ADDENDUM NO. 02

May 01, 2026

PROJECT: Baton Rouge Terminal Interior Upgrades
9430 Jackie Cochran Dr.
Baton Rouge, LA 70811

ARCHITECT: Washer Hill Lipscomb Cabaniss Architecture (LA) LLC, WHLC Architecture
1744 Oakdale Drive
Baton Rouge, LA 70810

E2.2

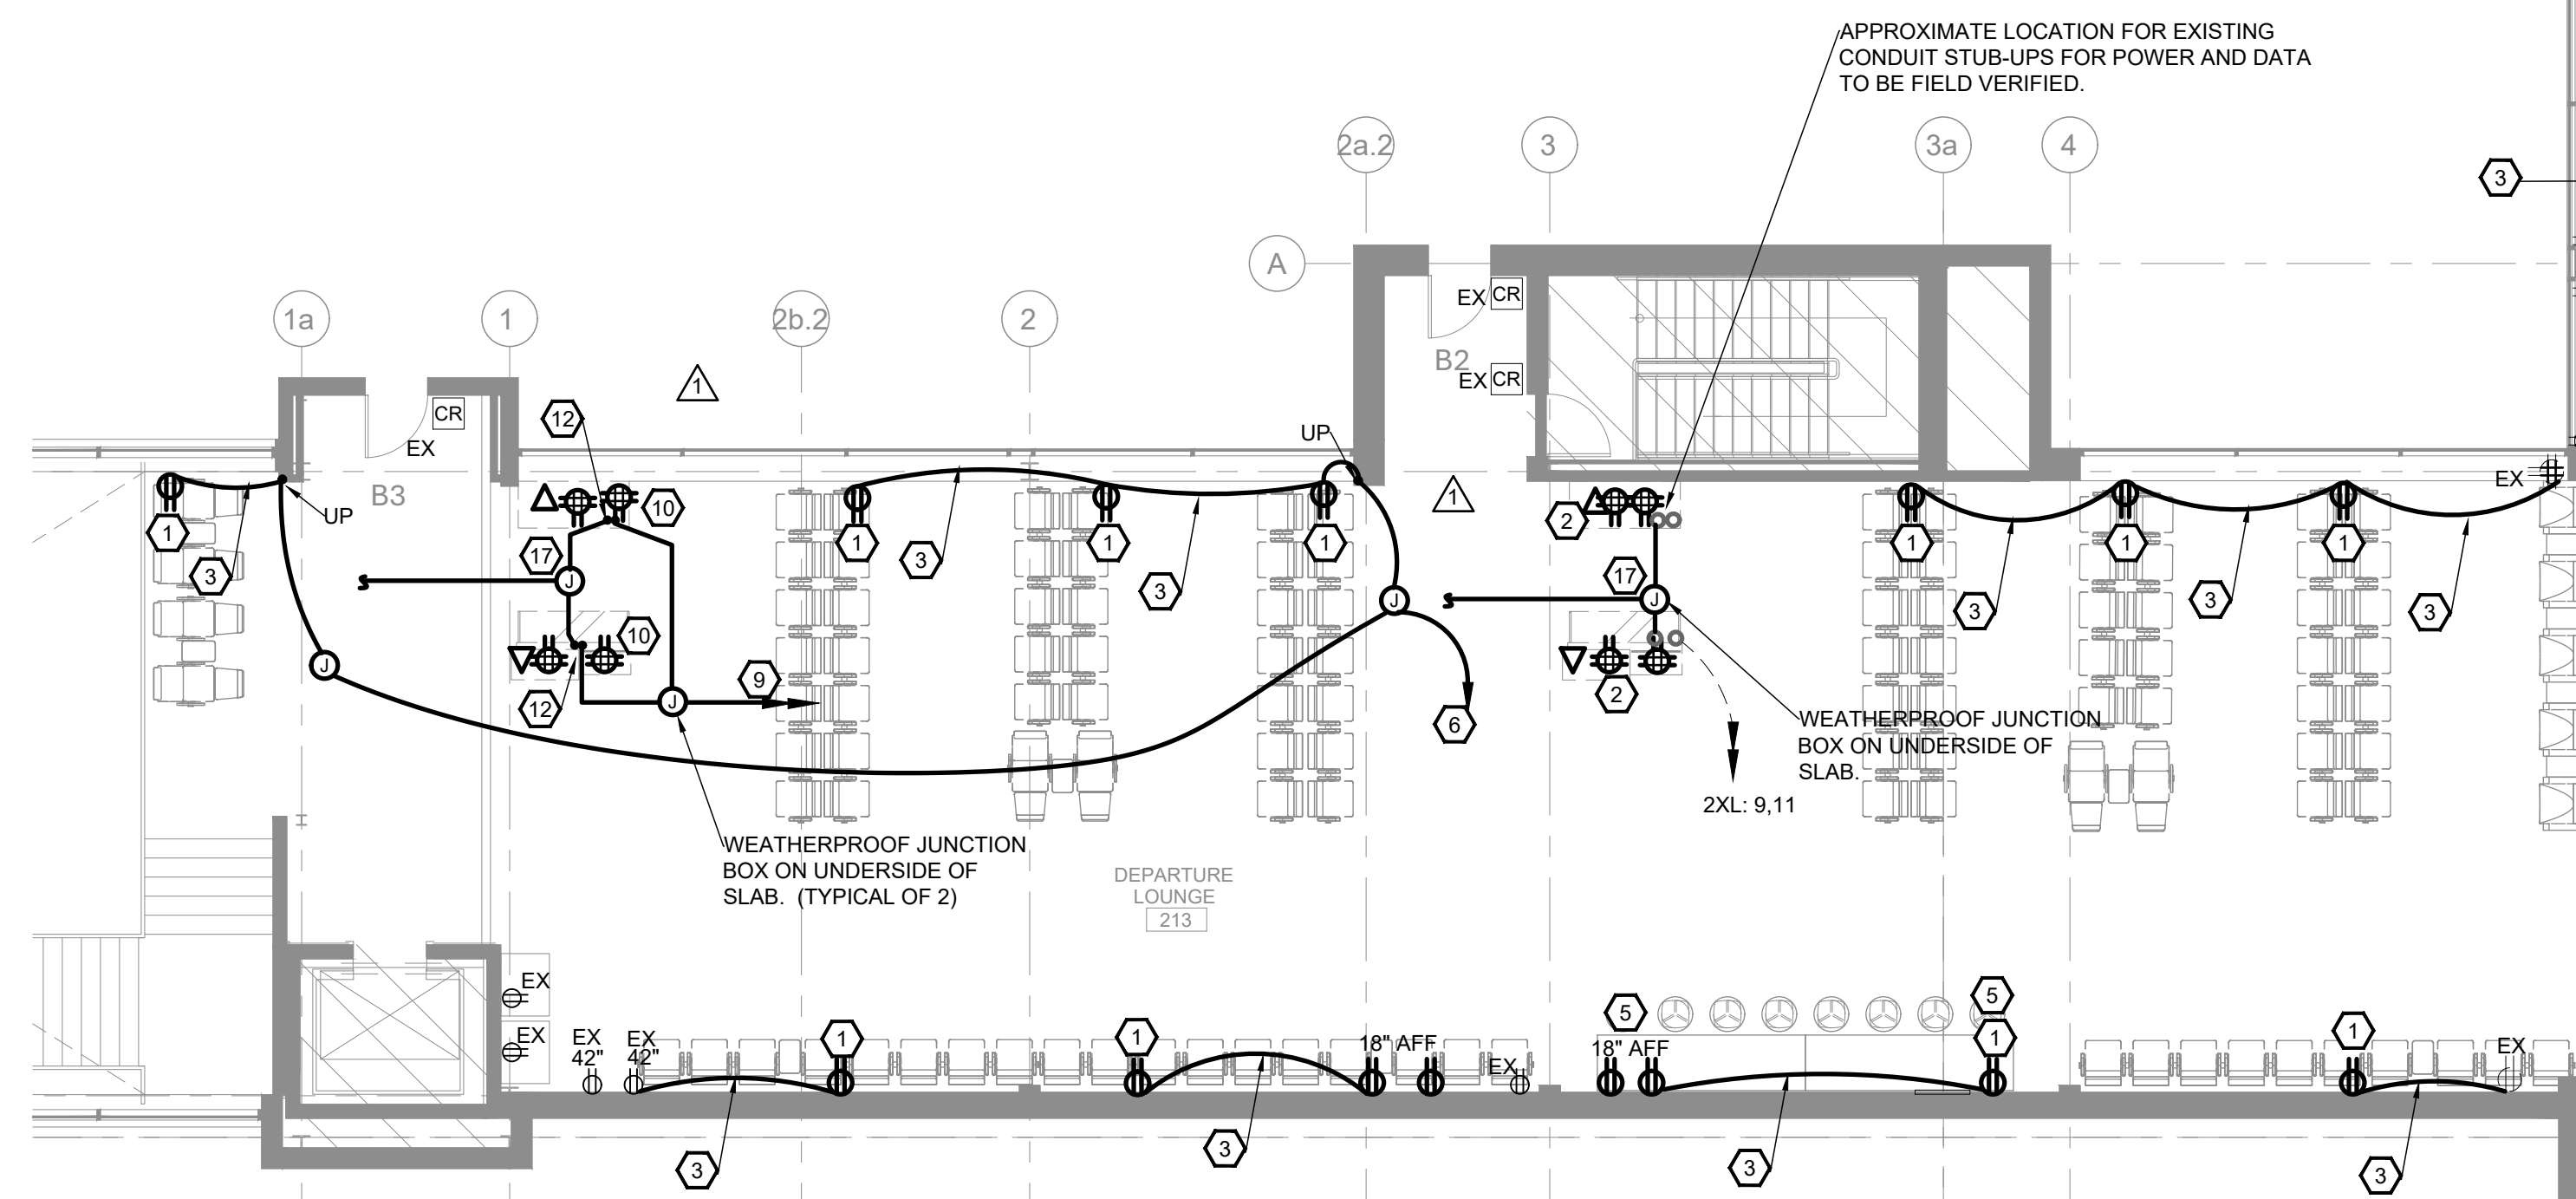
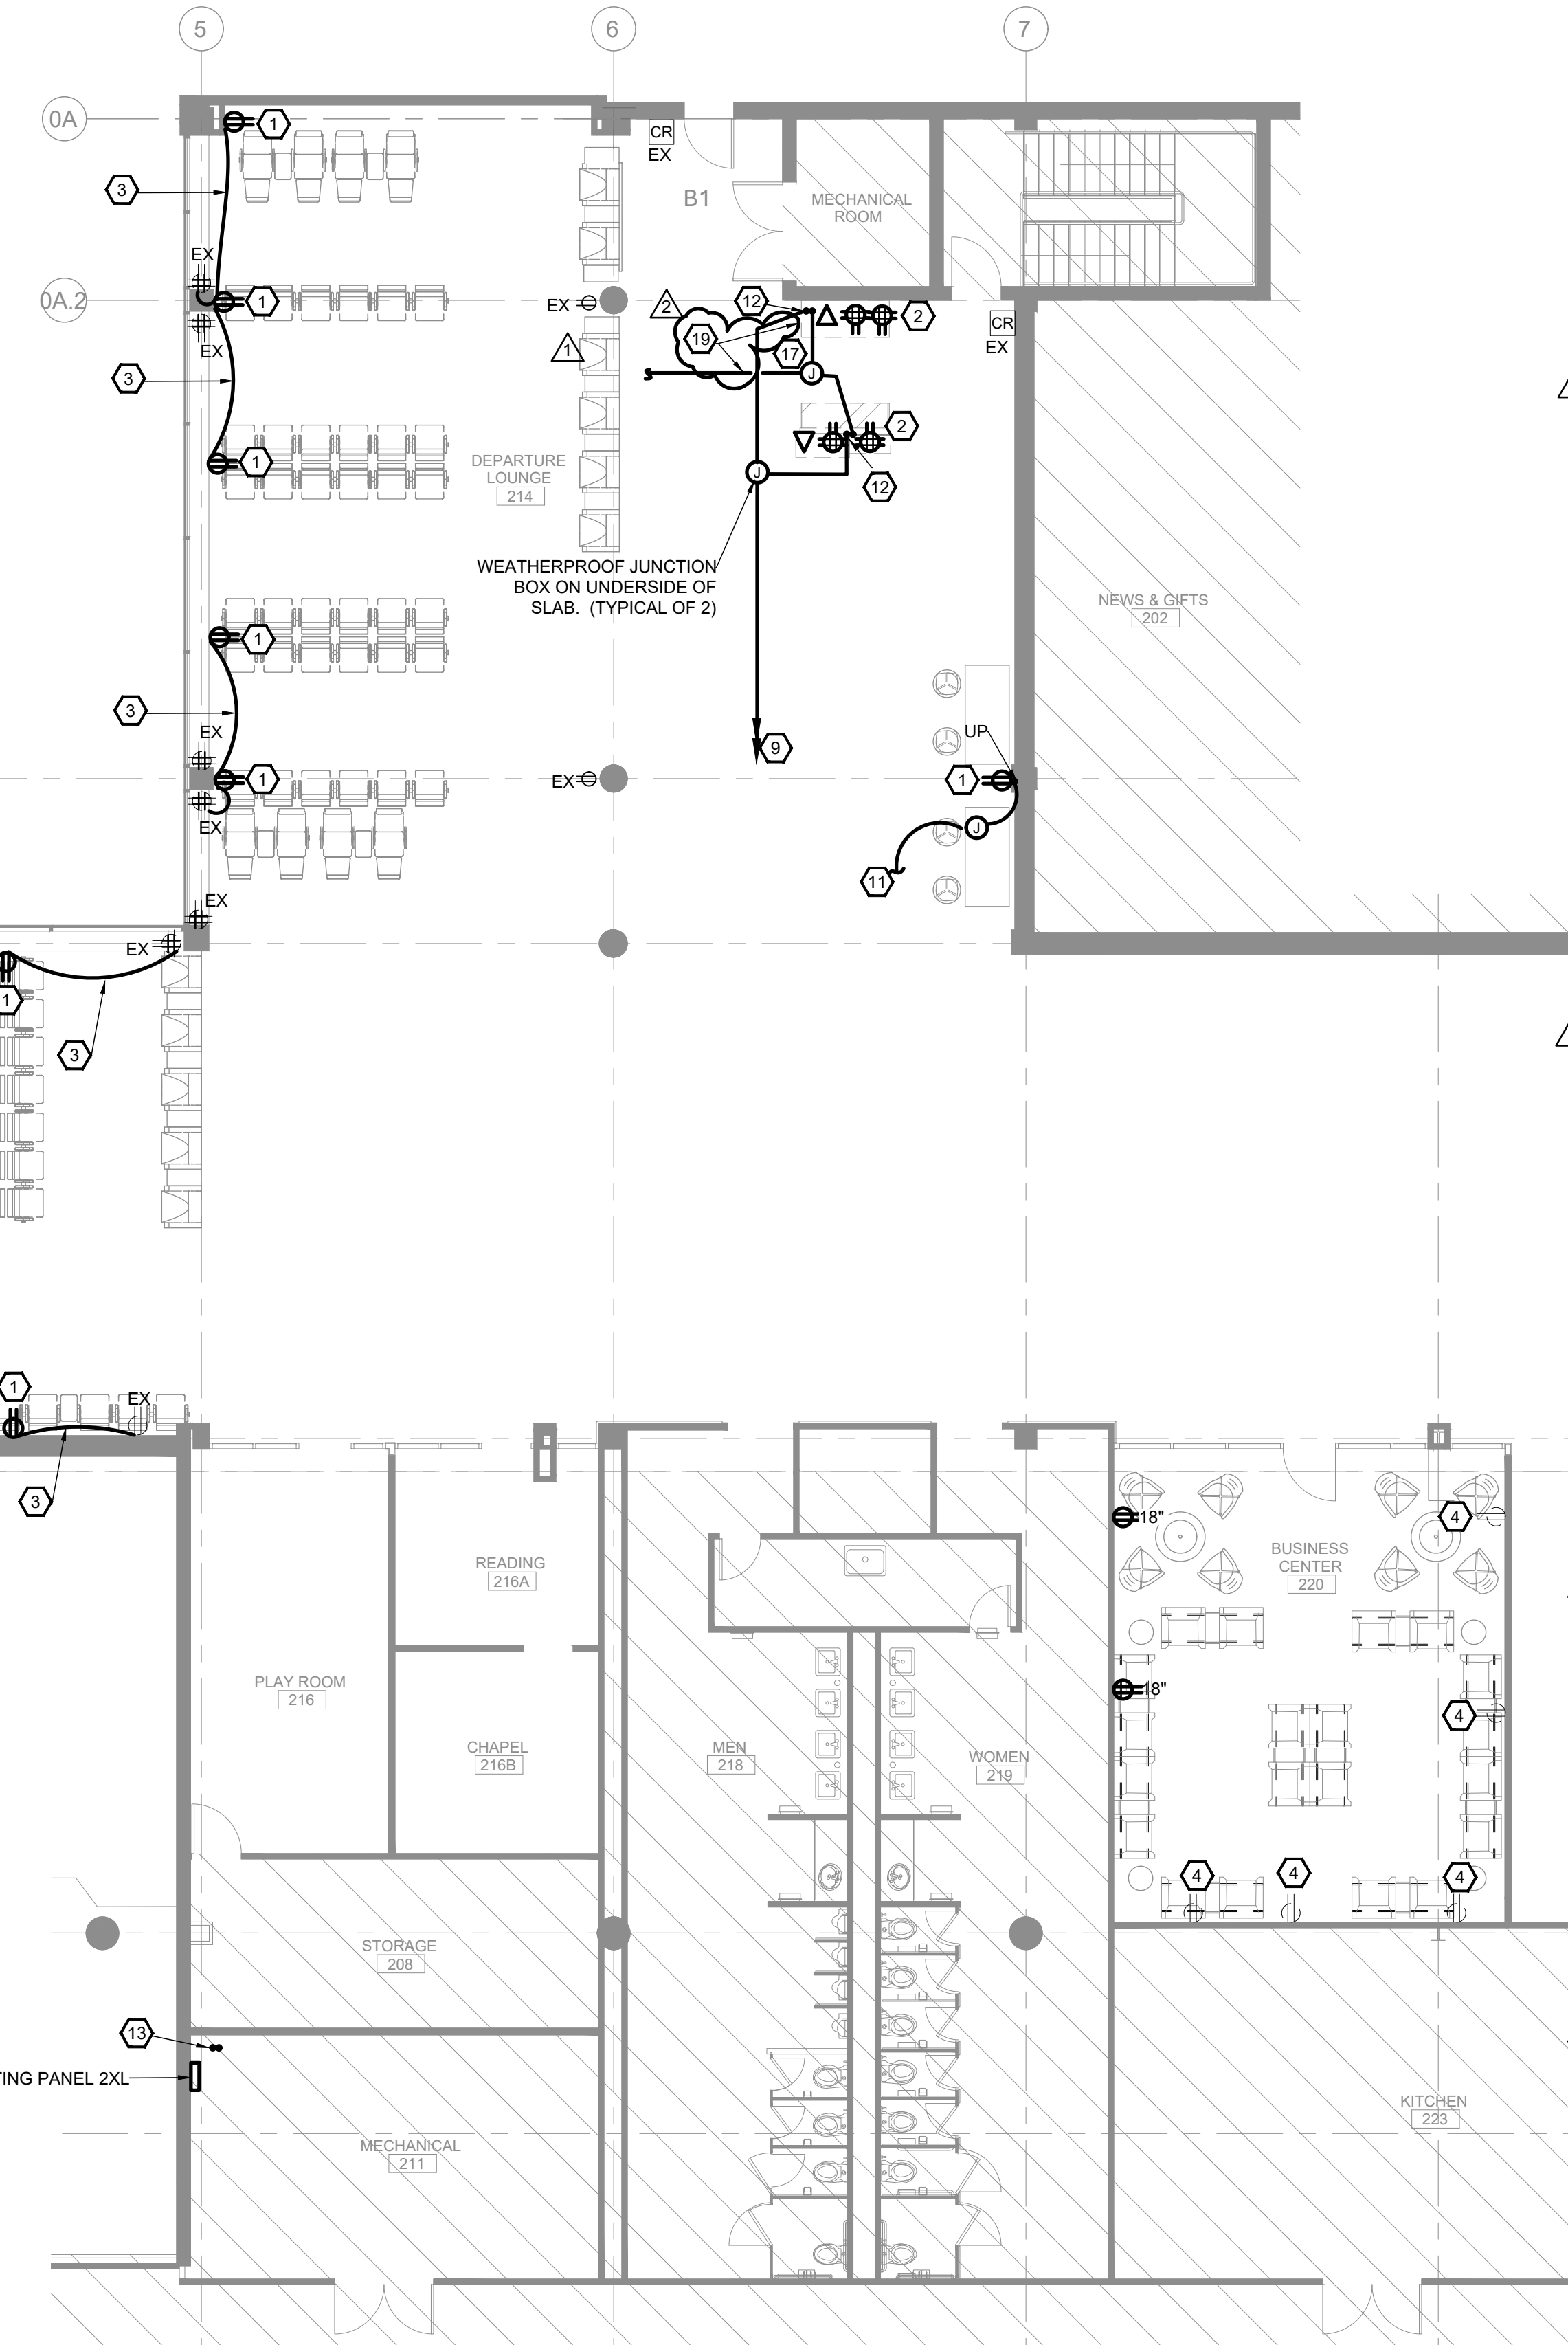
Sheet E2.2: See attached *revised* sheet. **1 page** (24"x36")
